Staff Supplement to CASE Report #2019-RES-IAQ-F

Date: April 12, 2018

Subject: Staff Analysis of Air Filter Pressure Drop and Air Filter Sizing (April 2018)

Figure 1. Pressure Drop for 20" X 30" X 1" Depth Air Filters – 3M Label Data

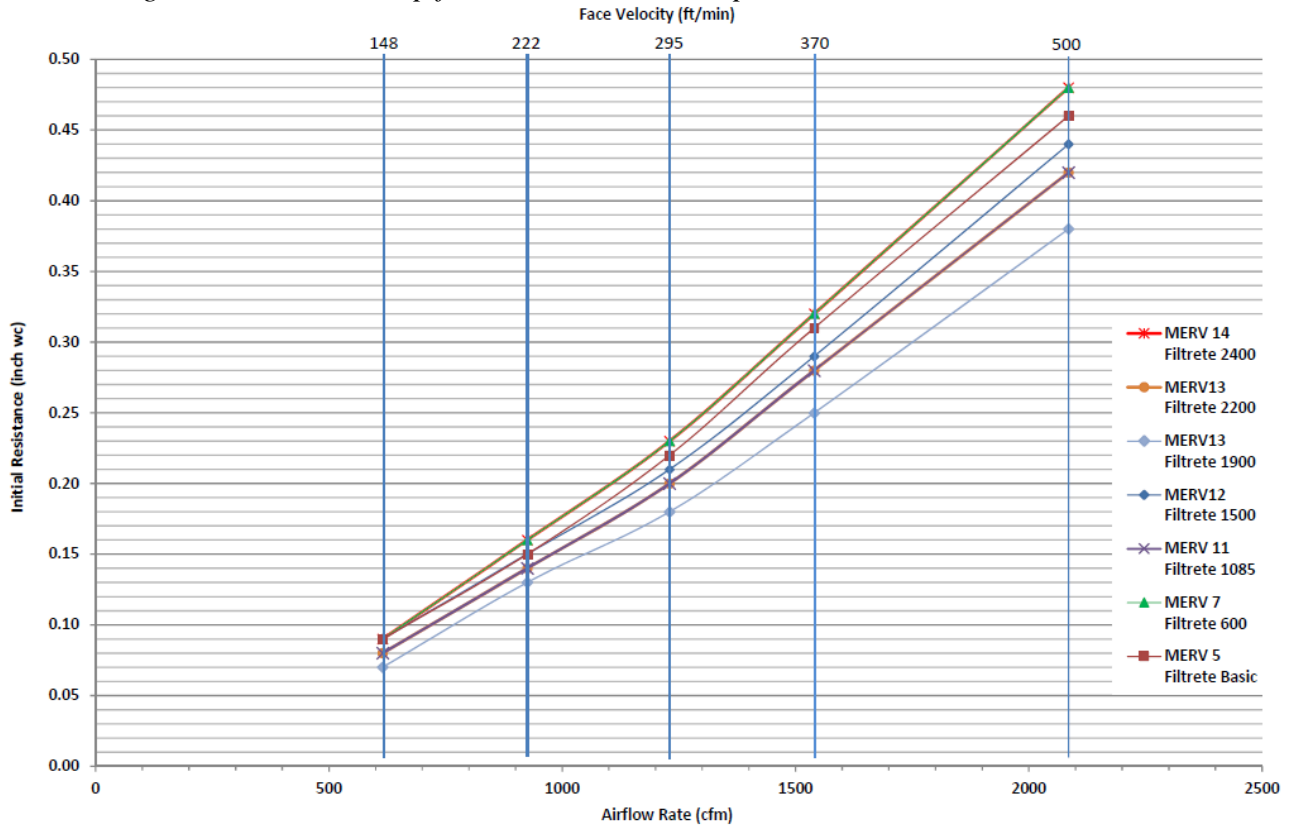
for 1" MERV 5, 7, 11, 12, 13 (two MERV 13 models), and 14 are plotted in Figure 1 below. The data indicate there is no significant correlation between MERV rating and pressure drop for these models. Note the highest pressure drop performance in this dataset is shared by MERV 7/MERV 14, the second highest pressure drop is for MERV 5, and the lowest pressure drops correspond to the MERV 13 models. Thus, the often-heard concern that MERV 13 filters would cause higher pressure drop in space conditioning systems does not apply to this 3M filter model lineup. Staff's understanding is that 3M air filter products represent a major share of California air filter sales.

Figure 2. 3M Manufacturer Pressure Drop Label Data Compared to Laboratory Measurements

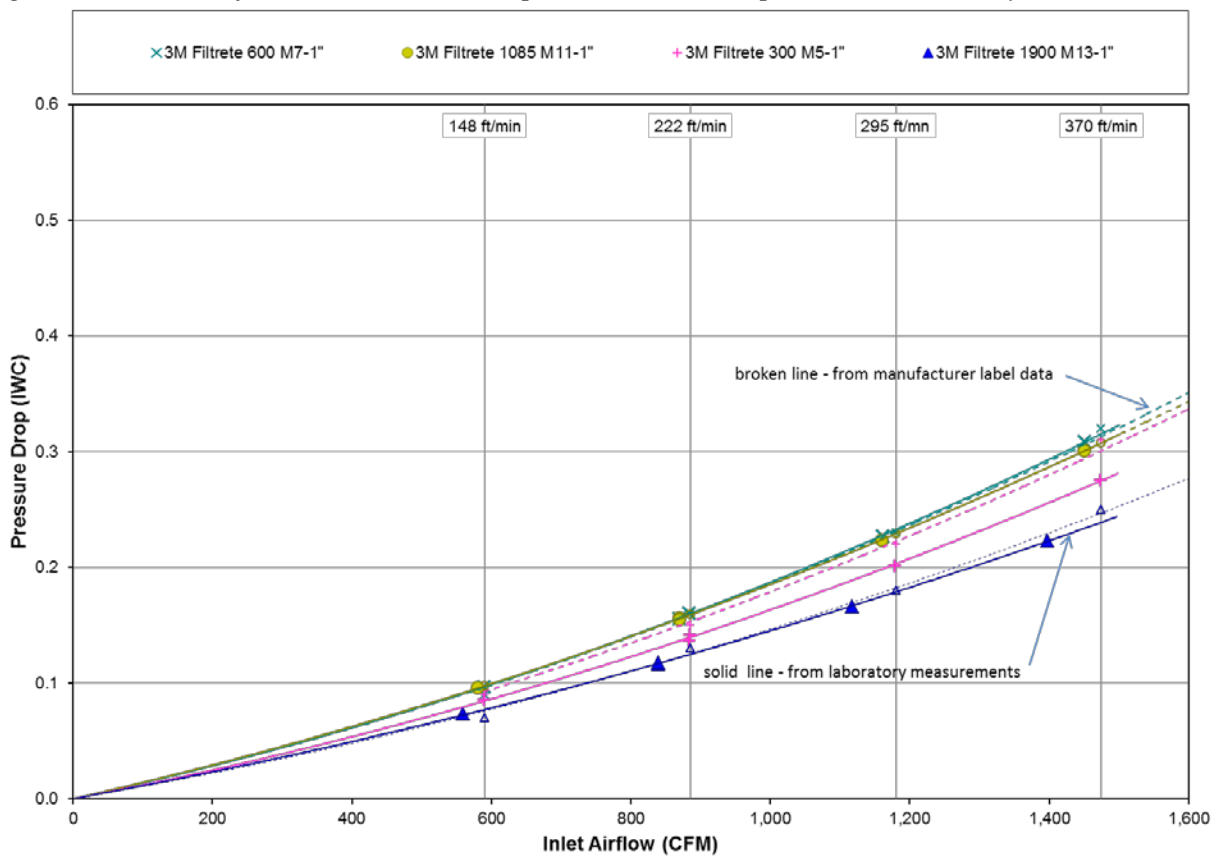
Figure 2 compares the 3M manufacturer's filter pressure drop data measured in the ATS laboratory with the pressure drop performance data from their product labels also plotted to facilitate comparisons. The manufacturer's label data is plotted with either a dashed or dotted line along with the performance data measured in the laboratory which is shown as a solid line. The tested pressure drop corresponded closely to the manufacturer's label data generally, and where the measured data diverges slightly from the published label data, the actual measured pressure drop is less than the published performance values, thus the actual performance was equal or better than published pressure drop and airflow specifications.

Figure 3. Pressure Drop Measurements – MERV 6, 7, 11, 13 Filters with 24" x 24" Face Area

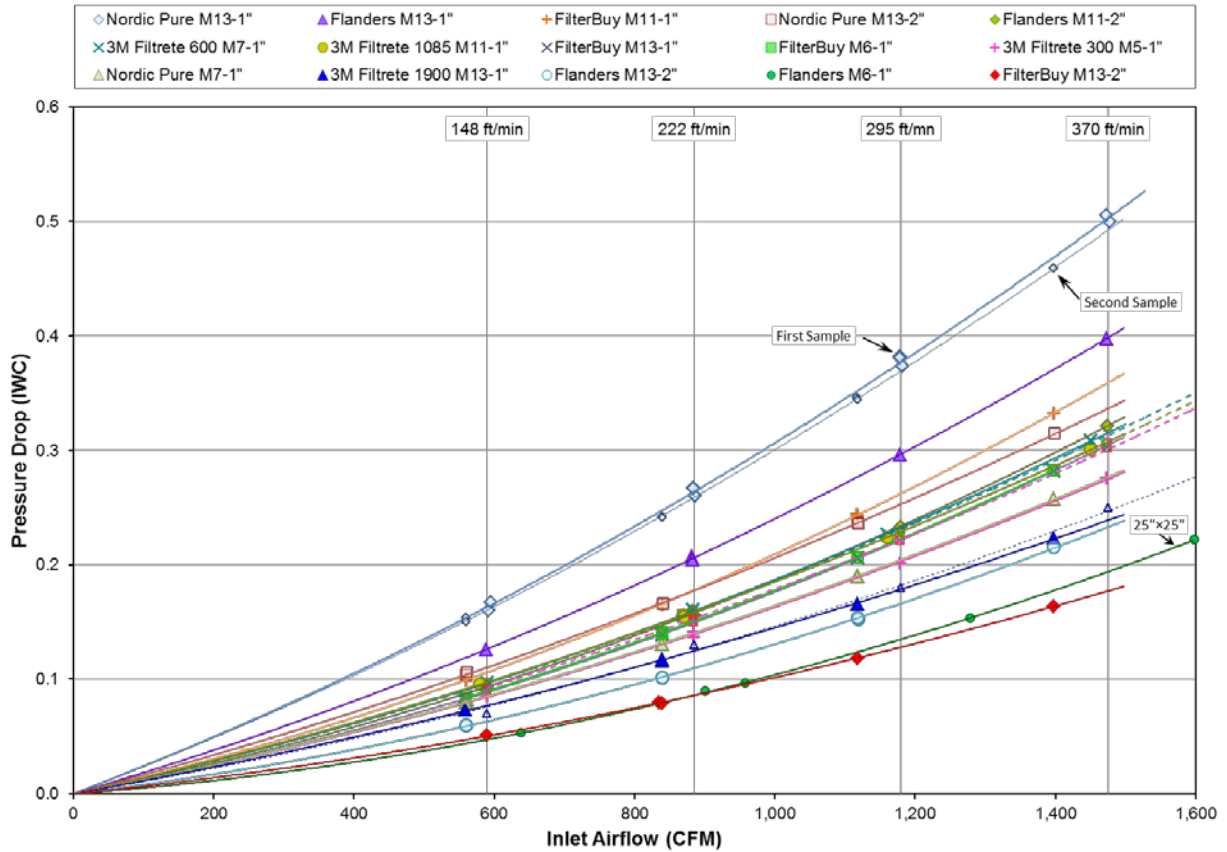
Figure 3 displays measured pressure drop for all fifteen filters tested in the ATS laboratory. Filter particle removal efficiencies in the test set included filters rated at MERV 6, 7, 11, and 13. Four of the filters were 2" depth, and the other 11 filters were 1" depth. The data indicates that there is no significant useful correlation between MERV rating and pressure drop for these models, consistent with the consideration of filter labels in Figure 1.

Figure 4. Pressure Drop Measurements – MERV 13 filters with 24" x 24" Face Area

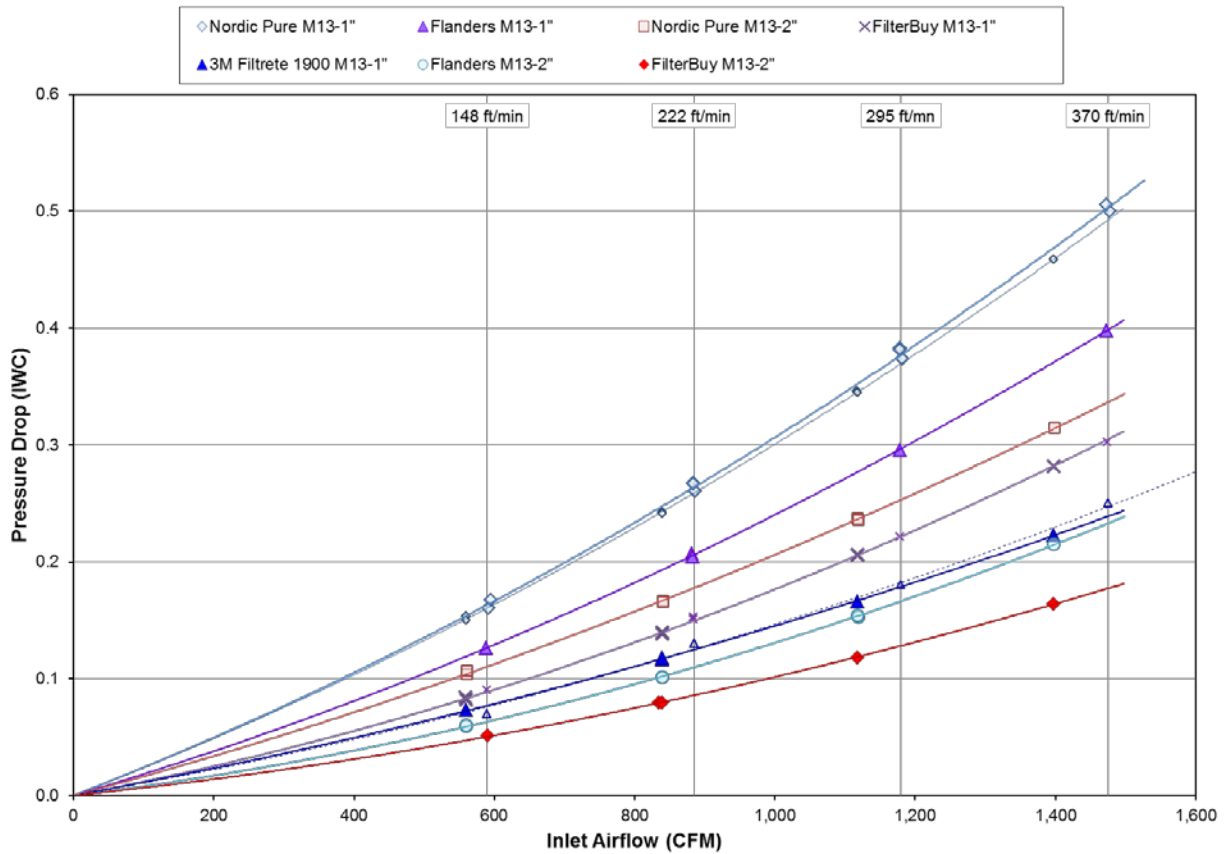
Figure 4 shows the subset of the tested filters that have a MERV 13 rating. Three of the filters are 2" depth, and the other four filters are 1" depth. Four of the filters have pressure drop less than 0.1 inch w.c. at 150 ft/min. 2" depth filters in this data set generally have lower pressure drop as compared to 1" depth filters. The filter with the highest pressure drop had measured airflow less than 400 cfm at 0.1 inch w.c. static pressure. The filter with the lowest pressure drop had measured airflow of approx. 1,000 cfm at the same 0.1 inch w.c. static pressure. This emphasizes the importance of air filter labeling since all of the 24" X 24" filters in this dataset could be installed in the same 24" X 24" filter grille in a system, but only one of these filters could meet a system requirement for approx. 1,000 cfm at 0.1 inch w.c. pressure drop.
